Urgent Field Safety Notice

MiniMed™ 780G insulin pump

Pump Errors After Quick Bolus - Software Update

Medtronic reference: FA963

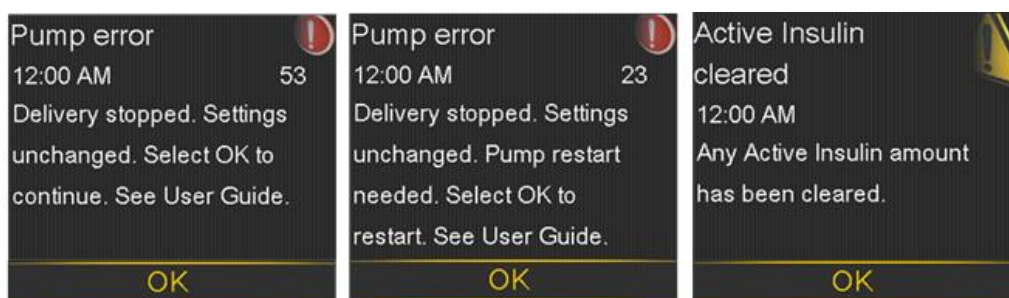
A software issue was identified in the MiniMed™ 780G pump with software version 6.5 when a large bolus is delivered at quick bolus speed.

This issue may result in pump errors if ALL of the following conditions are met:

- You have a MiniMed™ 780G pump with software version 6.5 and have not upgraded to software version 6.7.
- The bolus delivery speed is programmed to “Quick” in the pump settings (default is “Standard”).
- The SmartGuard™ feature is in use.
- The pump needs to be on the bolus delivery screen when an auto correction bolus is triggered. *Auto corrections are triggered when sensor glucose (SG) is running high and Active Insulin is low.*
- The bolus amount programmed to be delivered is greater than 17.1U.

Note: This can be a single bolus greater than 17.1U or a combination of boluses totaling greater than 17.1U.

If all the above conditions are met, within 2 minutes of bolus delivery completion, the pump initiates Pump error 53, followed by Pump error 23 alarm. The following screens are presented in the pump screen:

Upon clearing the pump errors, the pump resets and indicates Active Insulin has been cleared. The pump then guides the user to resume operation in Manual Mode. The SmartGuard™ status screen indicates the warm-up period has started. After approximately 5 hours, the SmartGuard™ feature will be available.

Since Active Insulin will display 0.0 units in the pump after experiencing the pump errors above, if the user is not aware of the amount of active insulin and delivers an additional bolus, there is a risk of insulin over delivery, which may result in low blood sugar (hypoglycemia) or severe hypoglycemia. In rare cases, severe hypoglycemia, if left untreated, may lead to a life-threatening situation.

Upgrade your MiniMed™ 780G insulin pump software to version 6.7 using one of the three options below:

1. Follow the step-by-step instructions contained in the Software Update Guide attached to this communication. The Software Update Guide can also be found by visiting our website at: <https://www.medtronic-diabetes.com/en-IE>.
2. Contact our Helpline on 015 111444 if you need assistance with performing the software update.

If you need to deliver large boluses (17.1U) at quick speed using your pump, the best step you can take now is to upgrade your MiniMed™ 780G insulin pump to software version 6.7.
